RCSC Middle School **HVAC Replacement**

Project # 2025.0008
January 13, 2026

ADDENDUM NO. A-3

1 FIRST FLOOR PHASING PLAN
SCALE: 1/16" = 1'-0"

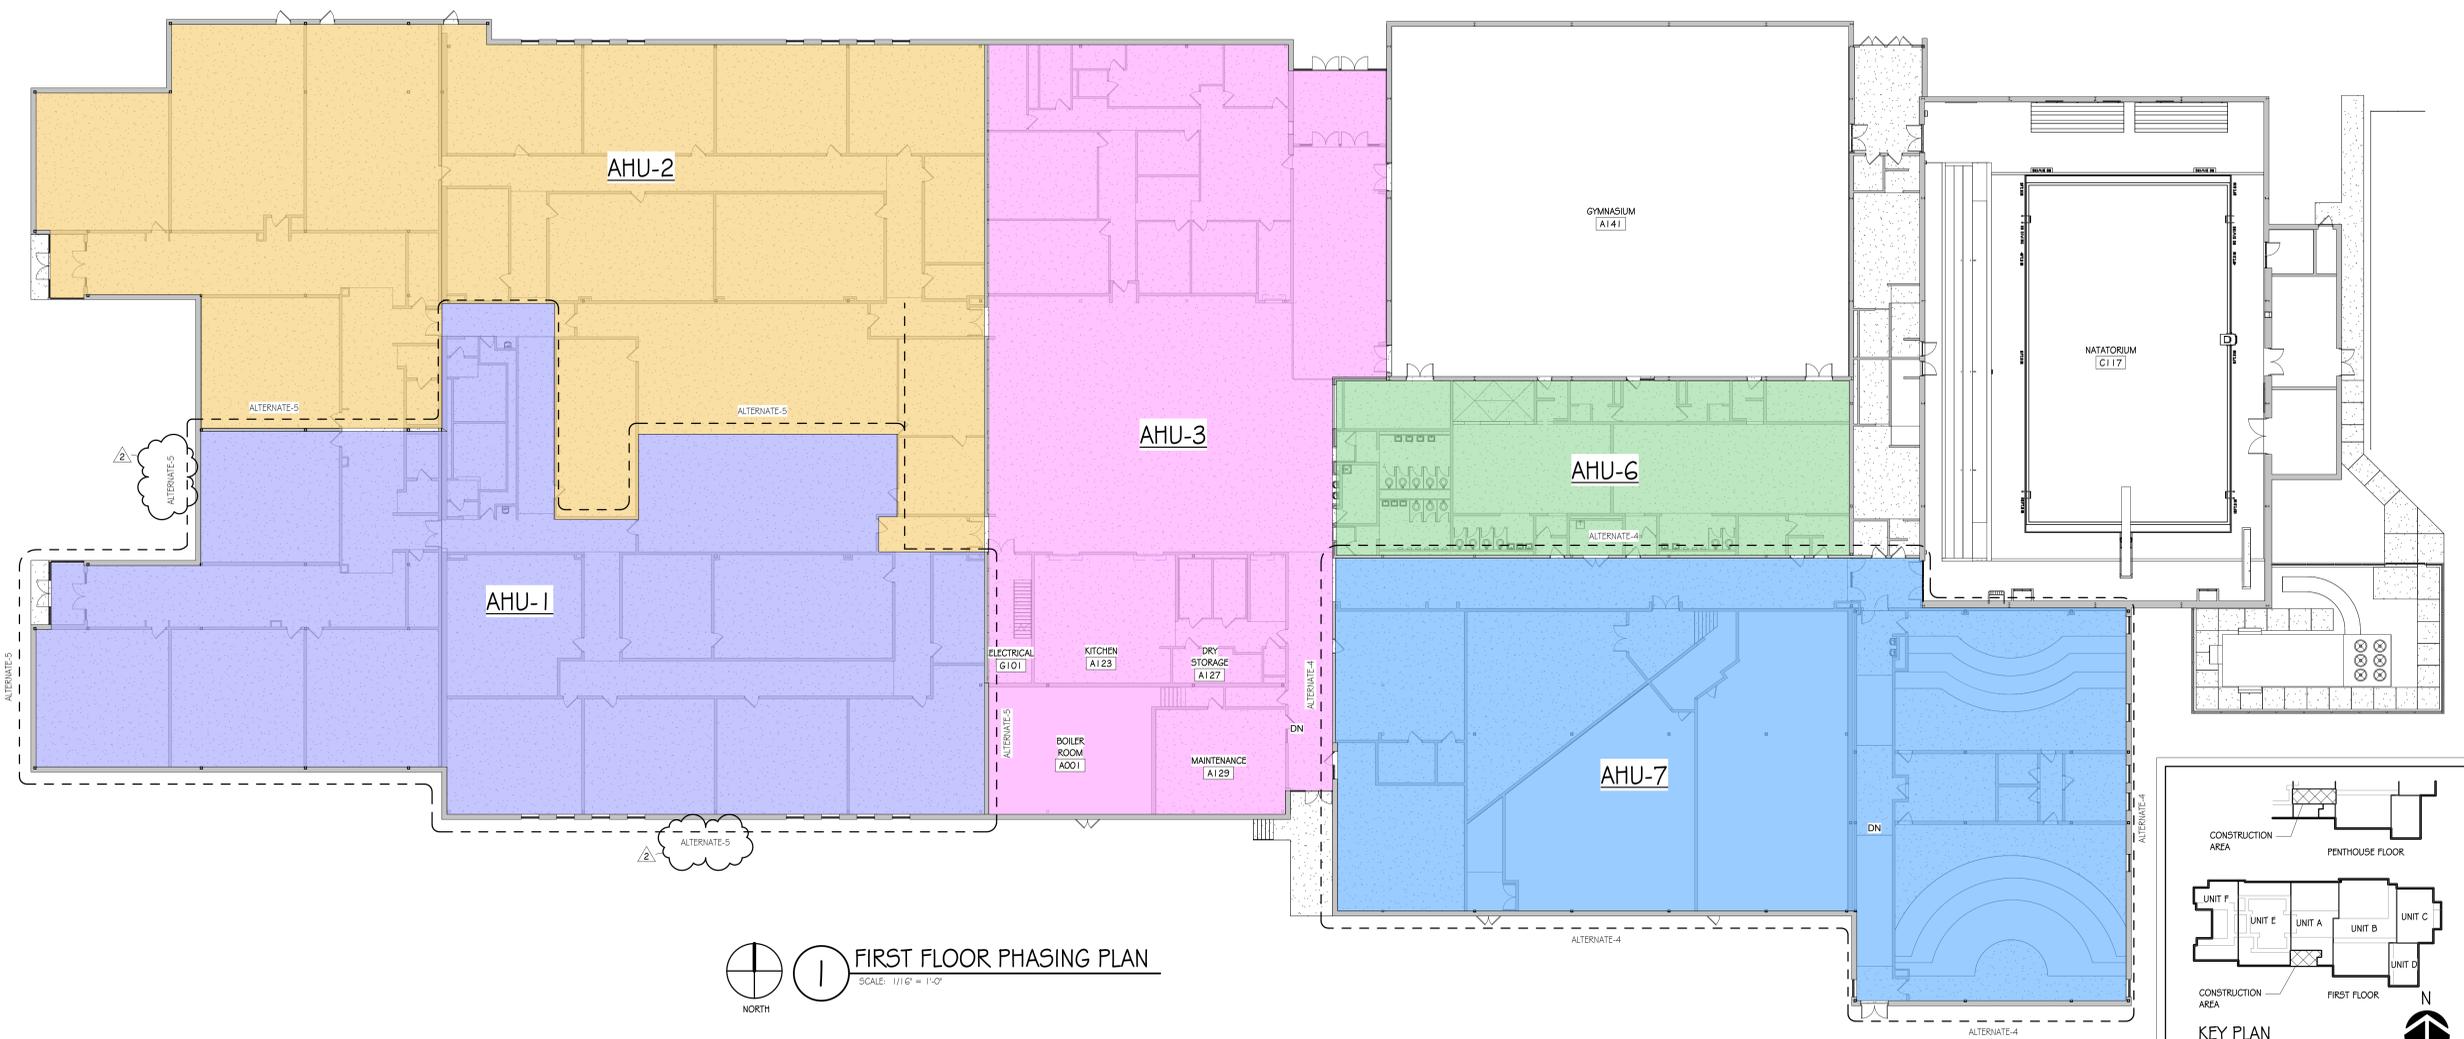
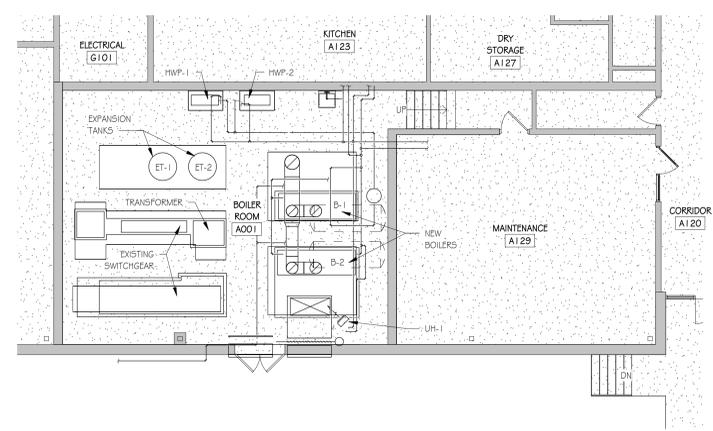
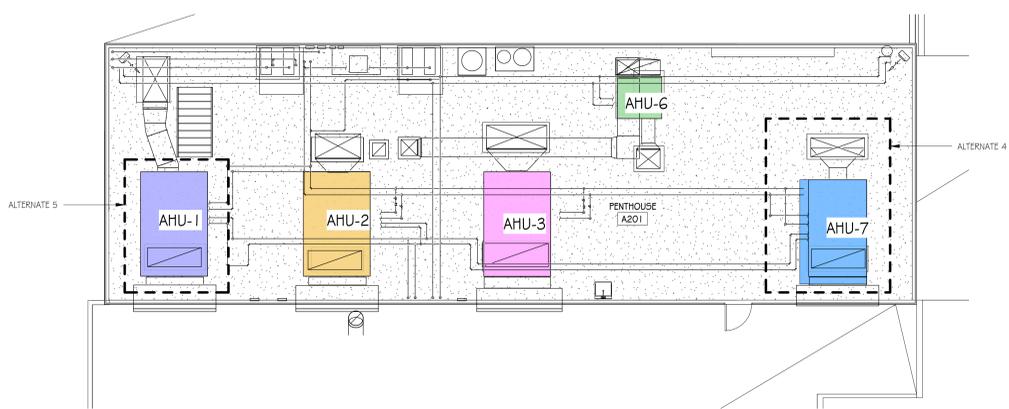
Description: Replace sheet G1.0 Phasing dated 1-12-2026 with new drawing dated 1-13-2026. Added a scope box with note around AHU-1, purple area.

2 LOWER LEVEL MECHANICAL PLAN
SCALE: 1/8" = 1'-0"
NORTH

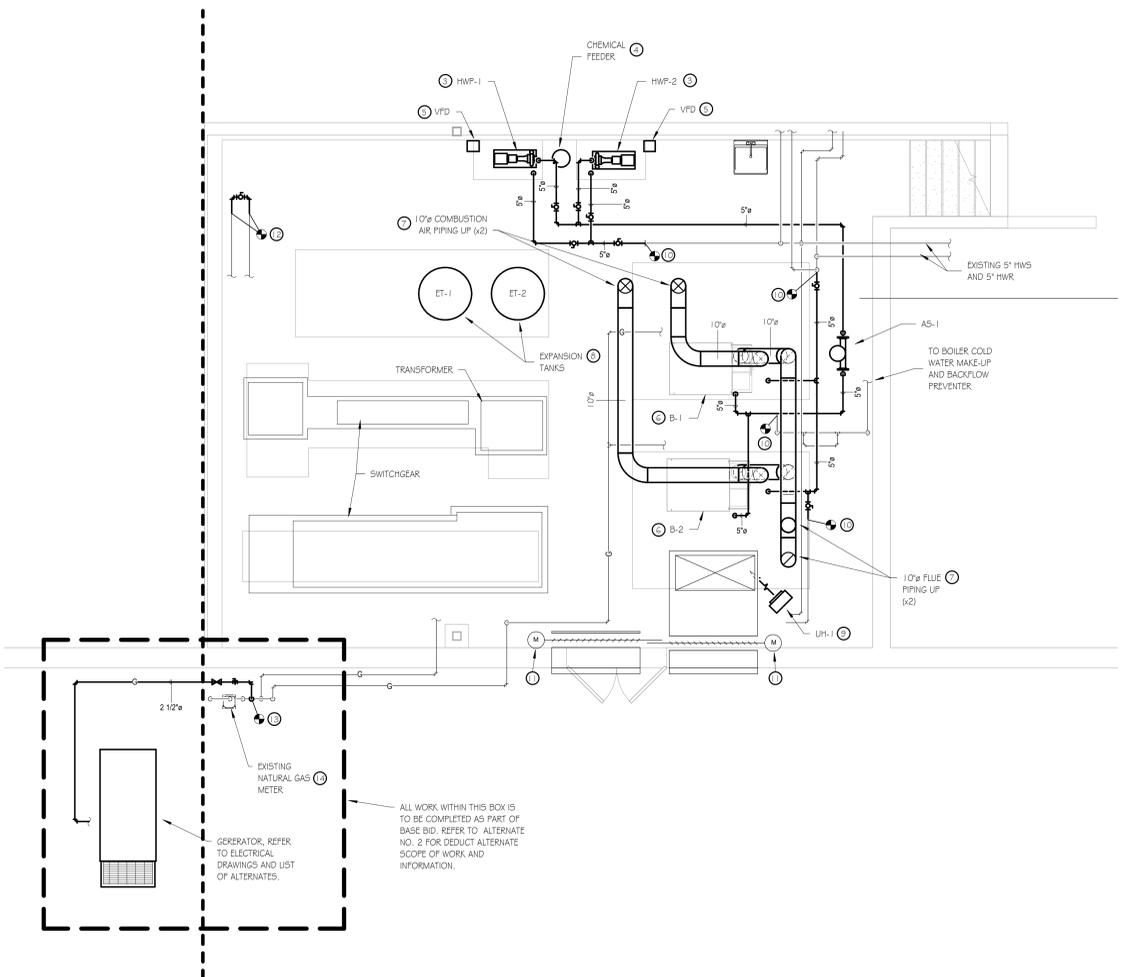
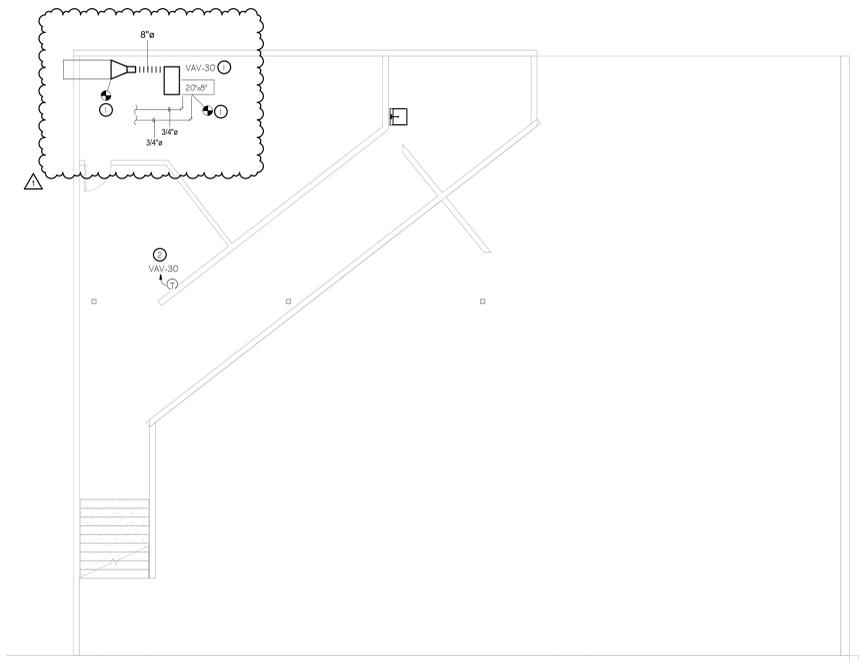
Item: **M-3.3**
Location: Mechanical Drawings: M1.0.
Description: Revision: Revise the Lower Level Mechanical Plan as shown on the attached revised sheet M1.0. Added hydronic piping size tags to the hot water piping that is connected to the VAV's and CUH's. All piping that is connected to the fin tube radiators is to be $\frac{3}{4}$ " \varnothing per the original documents.

FIRST FLOOR MECHANICAL PLAN - UNIT A
SCALE: 1/8" = 1'-0"
NORTH

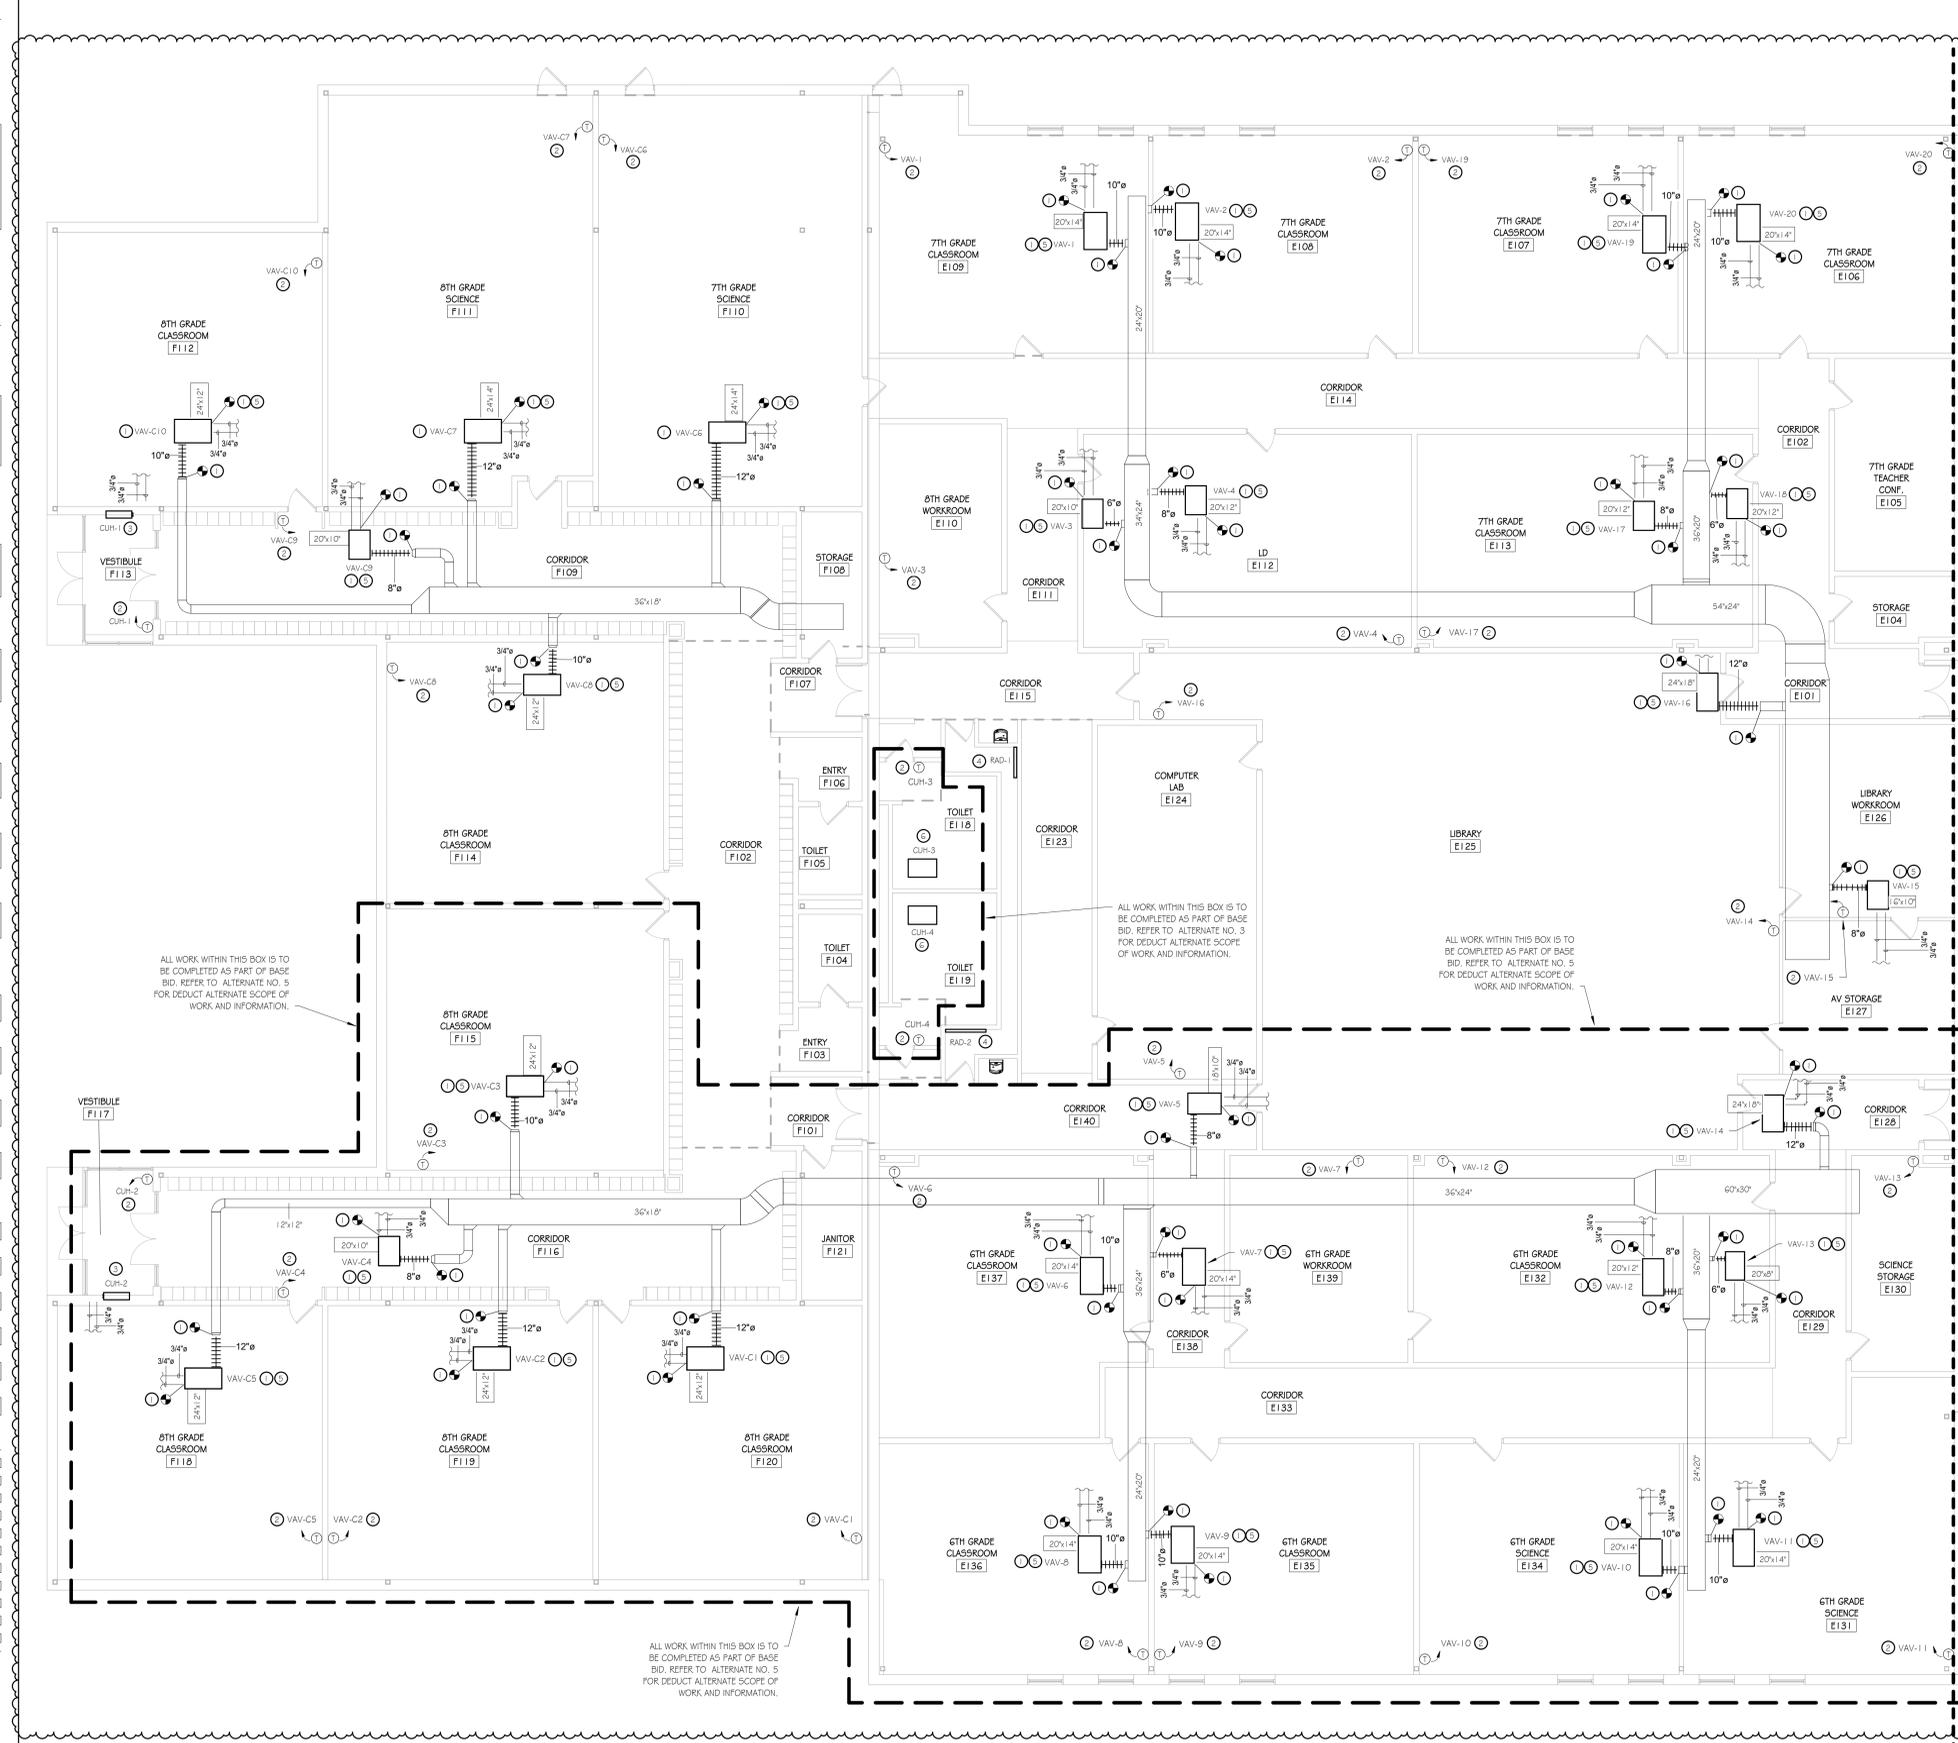
Item: **M-3.4**
Location: Mechanical Drawings: M1.1A.
Description: Revision: Revise the First Floor Mechanical Plan – Unit A as shown on the attached revised sheet M1.1A. Added hydronic piping size tags to the hot water piping that is connected to the VAV's and CUH's. All piping that is connected to the fin tube radiators is to be $\frac{3}{4}$ " \varnothing per the original documents.

Item: **M-3.5**
Location: Mechanical Drawings: M1.1A.
Description: Revision: Revise the First Floor Mechanical Plan – Unit A as shown on the attached revised sheet M1.1A. Added a dashed scope box around all ductwork and VAV's associated with air handling unit, AHU-1 to show the extent of work that is to be included in Alternate #5.

ALL WORK WITHIN THIS BOX IS TO BE COMPLETED AS PART OF BASE BID. REFER TO ALTERNATE NO. 5 FOR DEDUCT ALTERNATE SCOPE OF WORK AND INFORMATION.
